Request for Information #93

Project Name:	Construction of Victoria Park Arena and Brampton Sports Hall of Fame	Contract No.:	NRFP2024-232
Customer Name	City of Brampton	Prepared By:	Veronica Soulaka
Date Submitted:	June 23, 2025	Date Required:	June 30, 2025
Total Pages:	1 of 1

Description: Consult Mech. RFI #3 BAS Inquires

Various Questions related to BAS

Drawing: M-702 **Rev:**

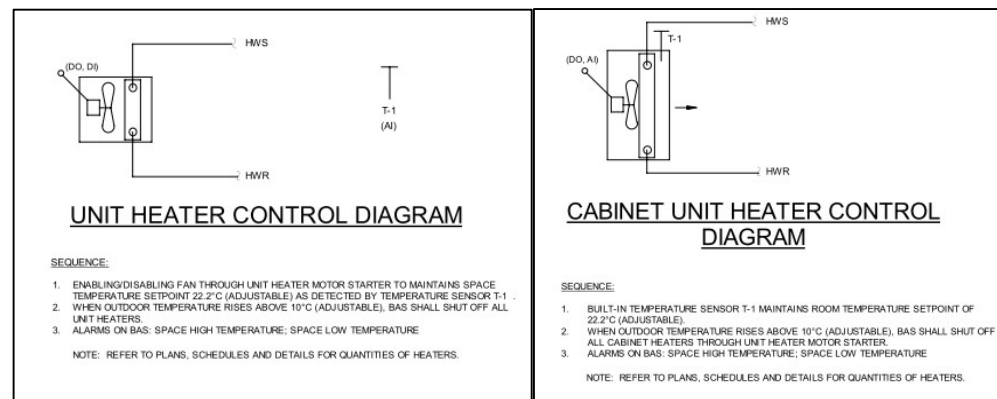
For the Unit & Cabinet Unit Heaters, the Control Schematics & Sequence of Operation shown on Drawing (M-702) didn't show/mention the Control Valve. However, the Schedules & Piping Schematics shows Control Valves. Hence, we are proceeding with the Control Valve for UH, CUH.

Please proceed with control valves.

Drawing: M-402E **Rev:**

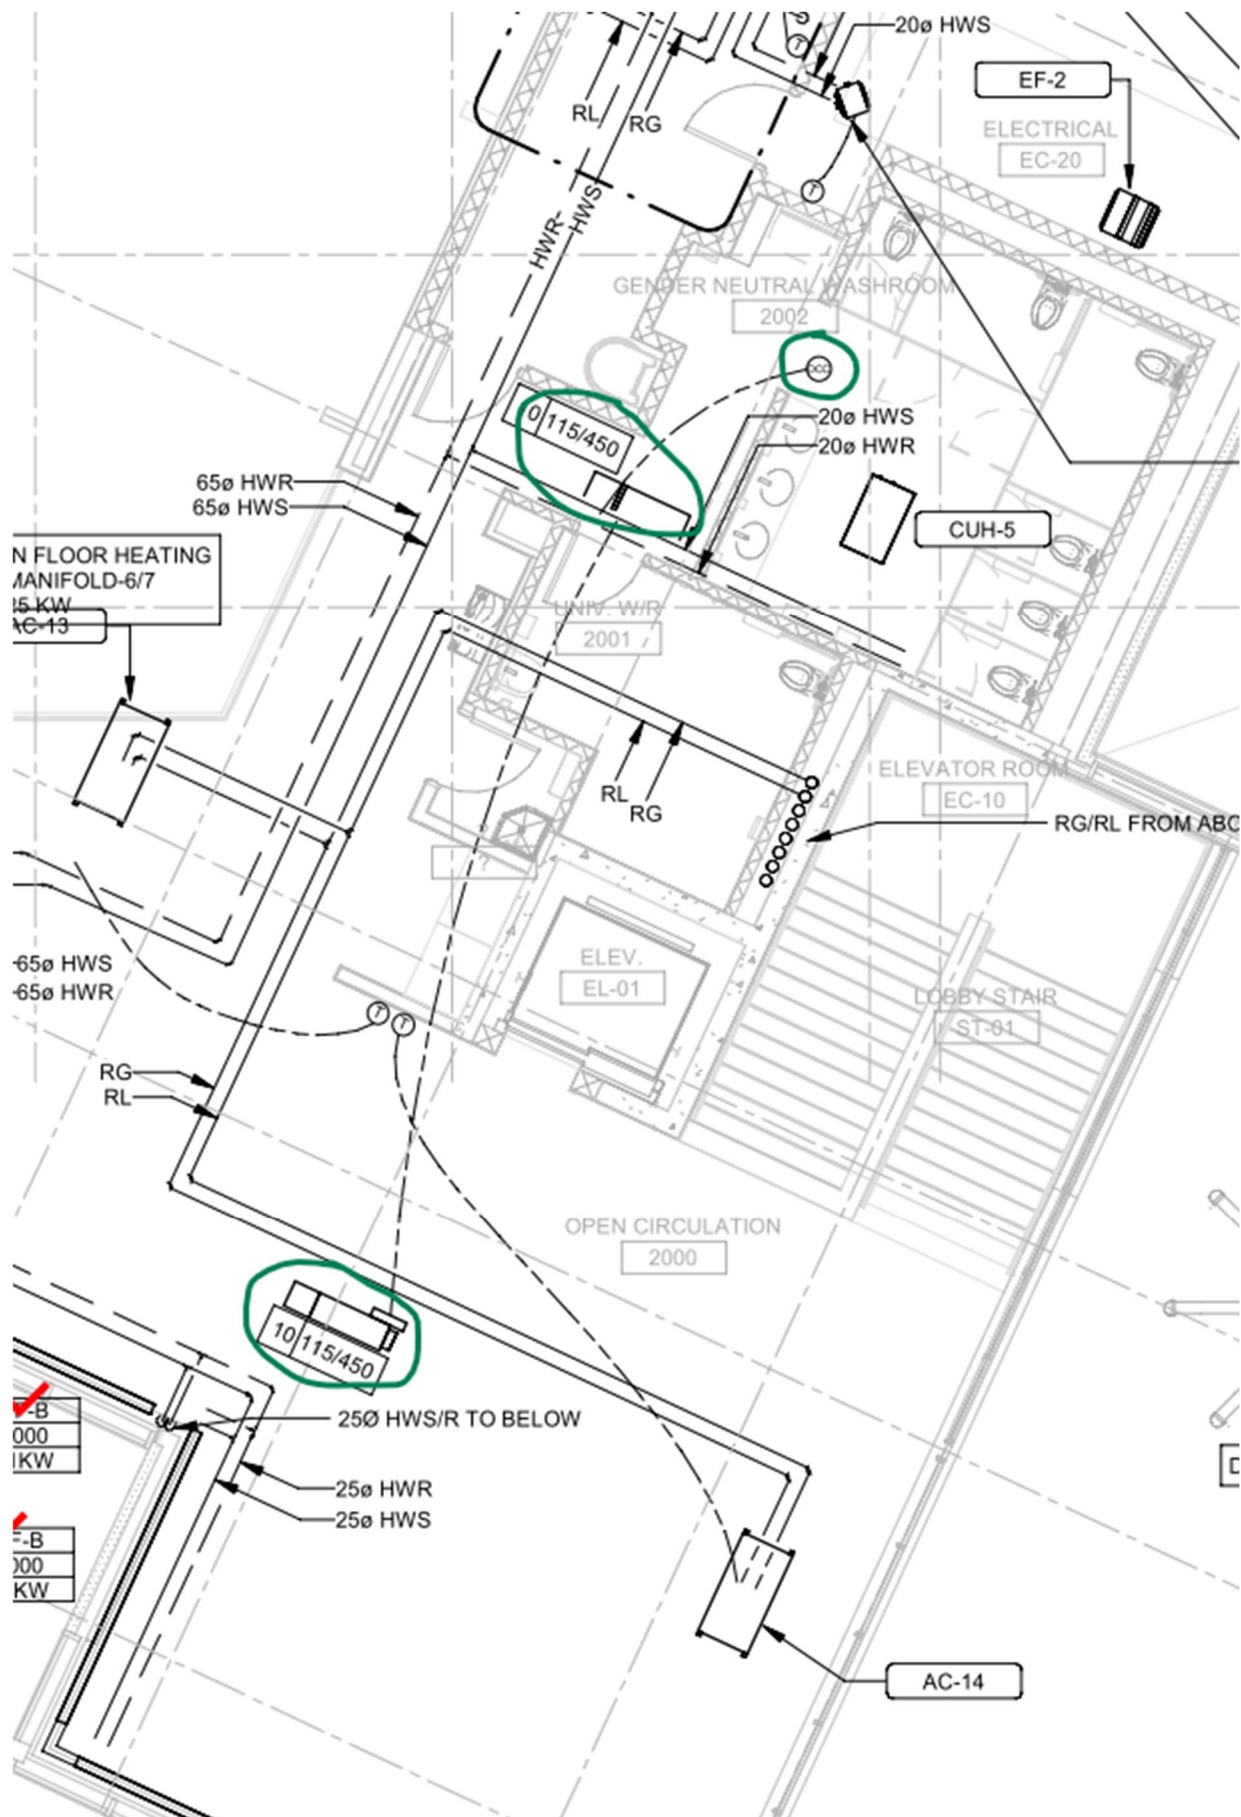
On Mechanical Drawing (M-402E), Supply Air VAV serves Open Circulation area for which we couldn't see any CO2 sensor tied. Since, the sequence of operation calls for Supply Air VAV's to maintain the zone CO2 Level. Hence, in the absence of the CO2 sensor can we assume to consider CO2 sensor as for others supply air VAV's shows. Kindly confirm.

Also, few room later, there is Toilet Exhaust VAV which is connected to the Open Circulation area VAV.

Since both these VAV's are serving different areas, we assume to work these VAV's independently to maintain their zone conditions.

Kindly confirm on the operation of these 2 VAV's.

NO CO2 sensor required for this space. The exhaust and supply VAV is required to be interlocked to ensure negative pressure is maintained in the washroom.

Drawing: M-402E

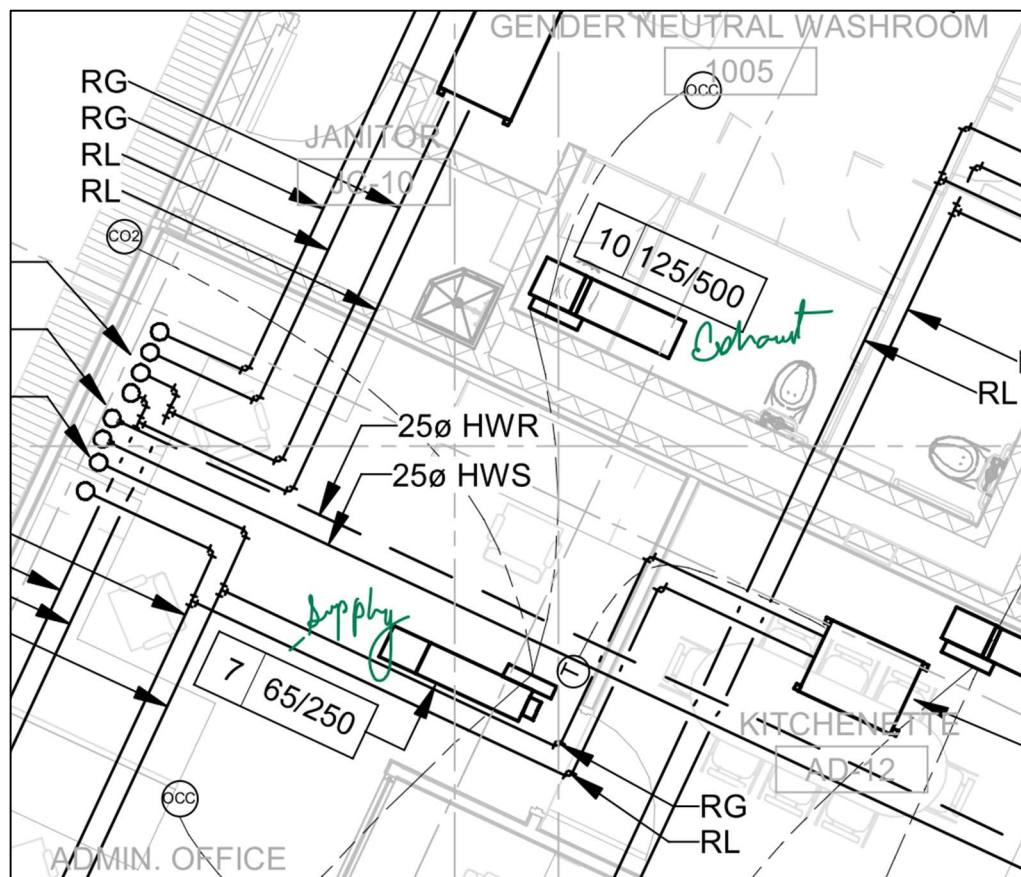
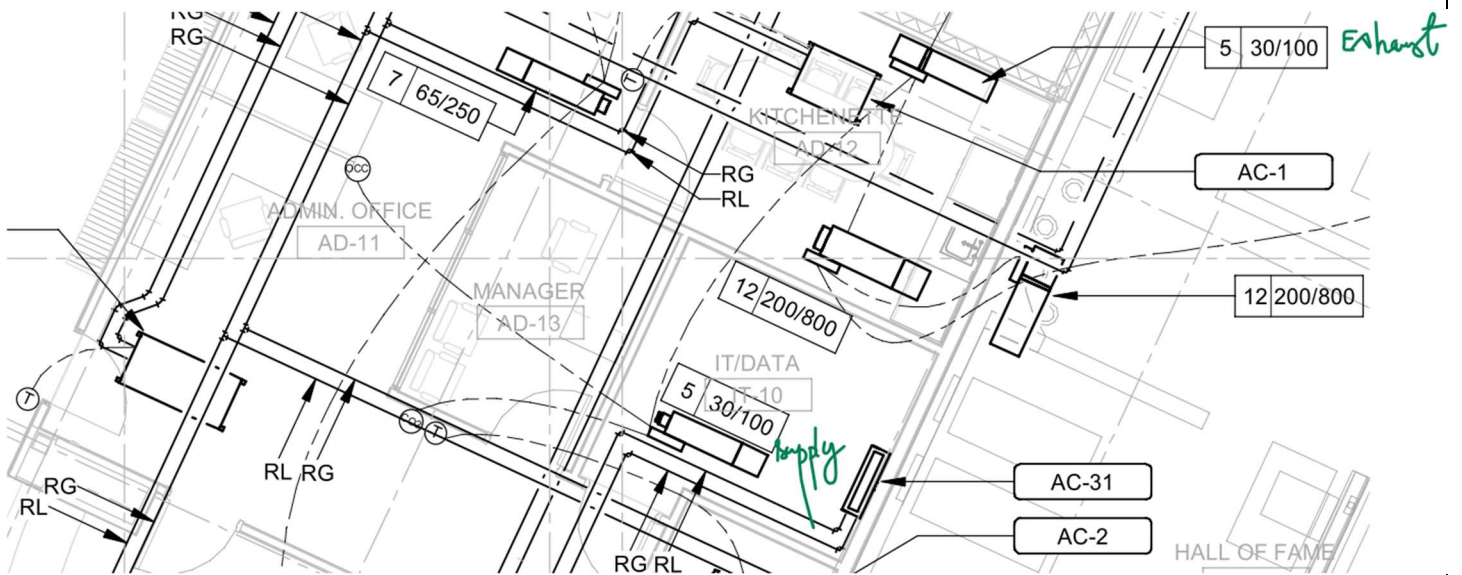
On Mechanical Drawing (M-301E & M-401E), Supply air VAV serves Admin Office area as shown on the below snap. However, it is shown as connected with Exhaust VAV which exhausts the air from Kitchenette area. These Boxes serve different areas however have same size; max/min flow & connected with each other.

Same goes with supply air VAV serving Admin Office & Exhaust VAV serving Gender Neutral washroom.

Kindly clarify on the Control strategy. We assume independent control since the serving zones are different. Please confirm.

Supply and exhaust VAVs to be interlocked to maintain required pressures in the space.

Drawing: M-702 **Rev:**

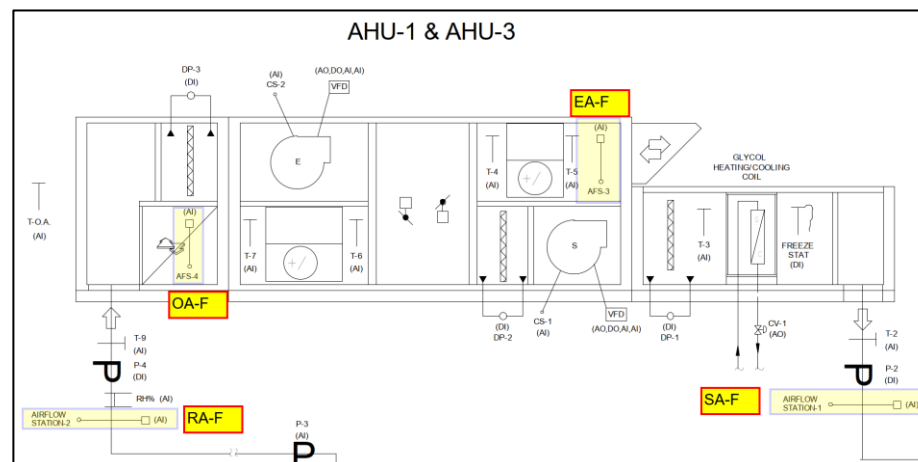
AHU-1 & AHU-3 fans are coming with the piezo rings & transducer per shop drawings i.e. SA-F & RA-F however, schematic shows them to be duct mounted. Also, OA-F & EA-F needs to be unit mounted as these AHUs are on the roof. Hence, please confirm scope for JCI to provide any airflow measuring stations for these AHUs.

Provide airflow sensors per contract documents. Coordinate with mechanical contractor and equipment supplier to ensure compatibility and integration.
